CITY OF KELOWNA
MEMORANDUM

APPLICATION NO. Z07-0008

PURPOSE: TO OBTAIN A ZONE AMENDMENT, A DEVELOPMENT PERMIT AND A DEVELOPMENT VARIANCE PERMIT TO ALLOW FOR THE CONSTRUCTION OF A 4-STOREY 40-UNIT MULTI-UNIT RESIDENTIAL DEVELOPMENT

1 EAST ELEVATION
SCALE 1:100

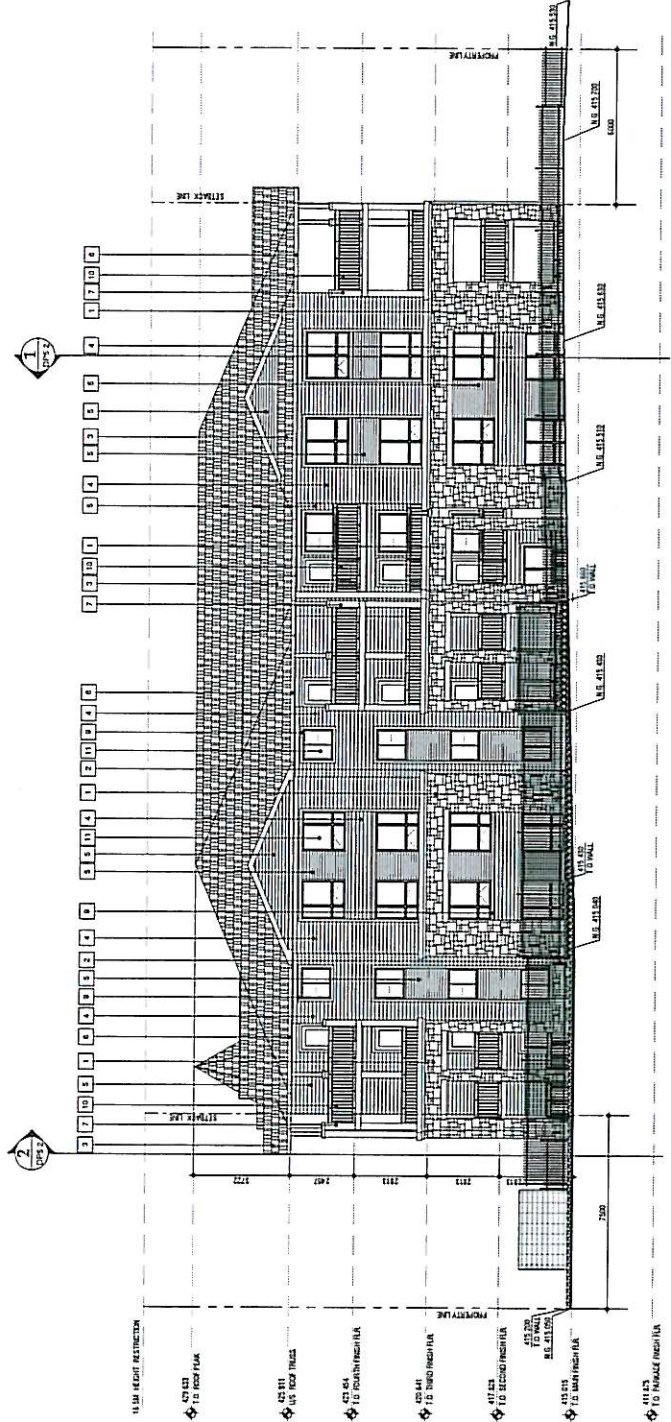
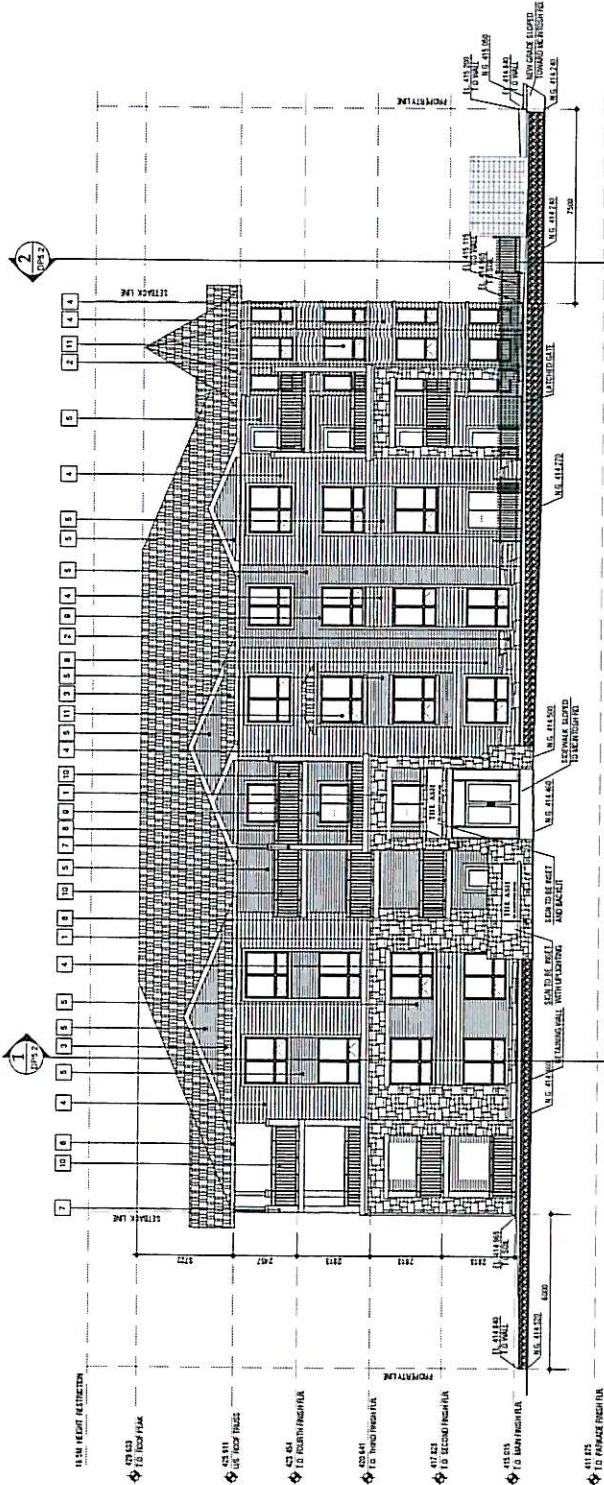
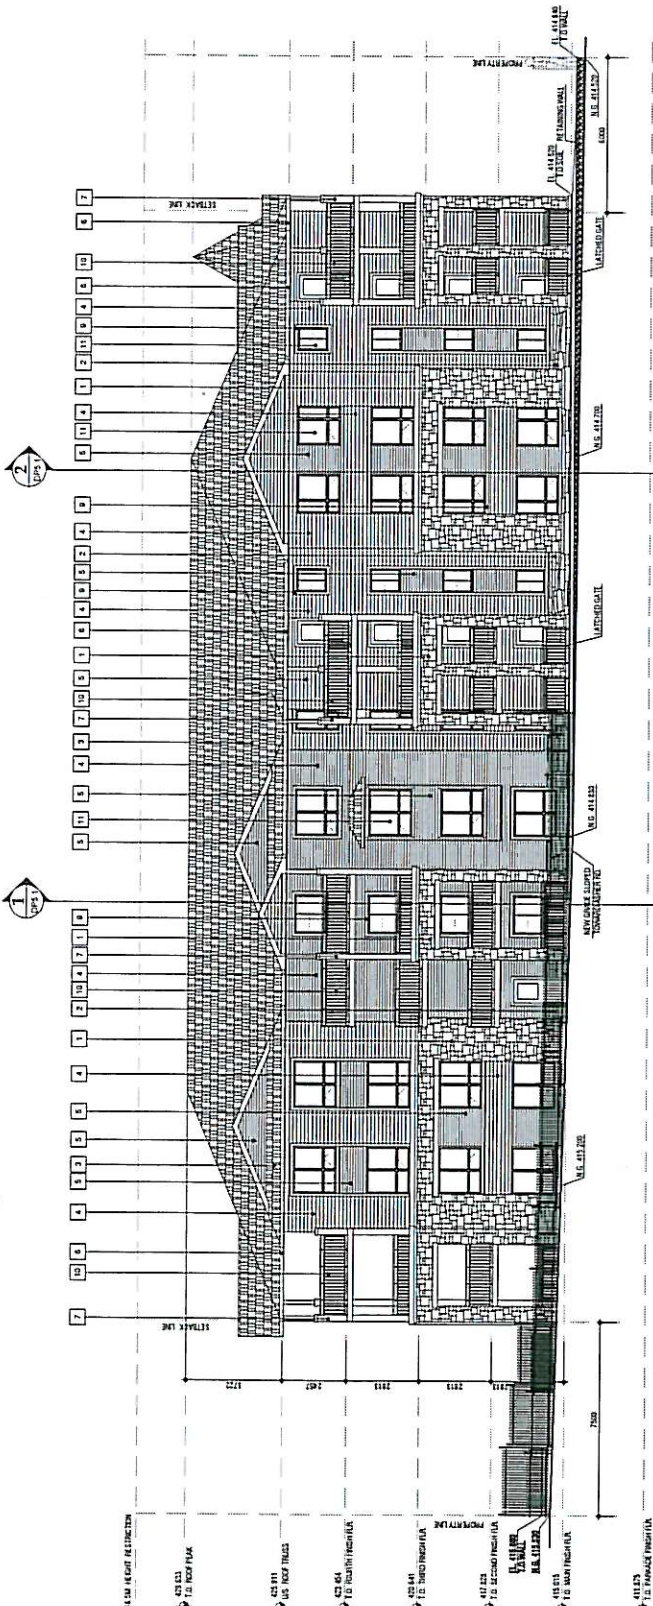
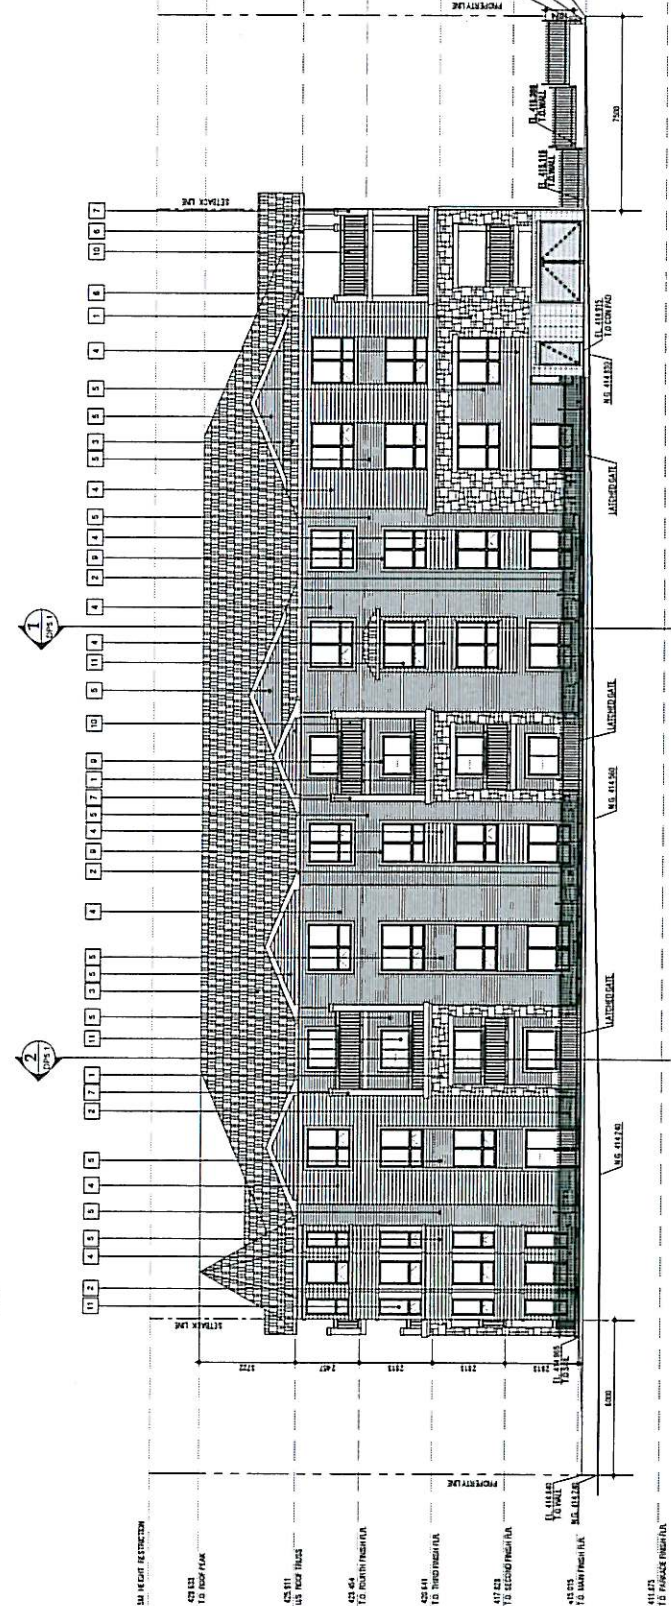
The applicant has incorporated most of the requested changes with the exception of the proposed use of vinyl siding over the stated preference for hardiboard products. The developer has provided correspondence addressing this issue specifically, a copy of which is attached as Attachment 'Q' for your information and reference. Also included in Attachment 'Q' is further correspondence from the applicant dated June 20, 2007 the reinforces the applicant's position with respect to vinyl siding as the appropriate material choice rather than hardiboard siding.

Further to the Design Review Committee comments, particularly item 1.9 "Exterior finish details with preference to hardi-plank type finish over vinyl siding", please find below, our comments, as to why we have not included for this type of exterior finish product to this building.

First and foremost, is the fact that hardi-plank type products present a potential health hazard, as the products contain silica (see below), for installers, other workers in the vicinity of the product being installed, as well as future owners and/or tenants should the dust from cutting and drilling find it's way into cavities, ducting, etc, or simply having the dust airborne. We understand that the siding industry is having a difficult time in finding trades people to install this type of product due to the silica component. We wish not to put anyone in harms way.

We have also found that vinyl products provide better details at window and door jambs, do not require extensive caulking which need regular maintenance, joints are lapped not butted, etc. and also offer equivalent warranties.

Siding Material - We are still of the position that vinyl siding is an appropriate material choice rather than Hardi-board for the following reasons:

- as suggested in the letter from the client dated April 12, 2007, the silica dust is a health risk and is indicated as such in the manufacturer's literature

- Hardi Board requires regular maintenance in terms of painting and caulking as indicated in the manufacturer's literature and on their website

- from a distance both vinyl and Hardi Board have the same appearance. Please see the attached images of houses 1 & A.
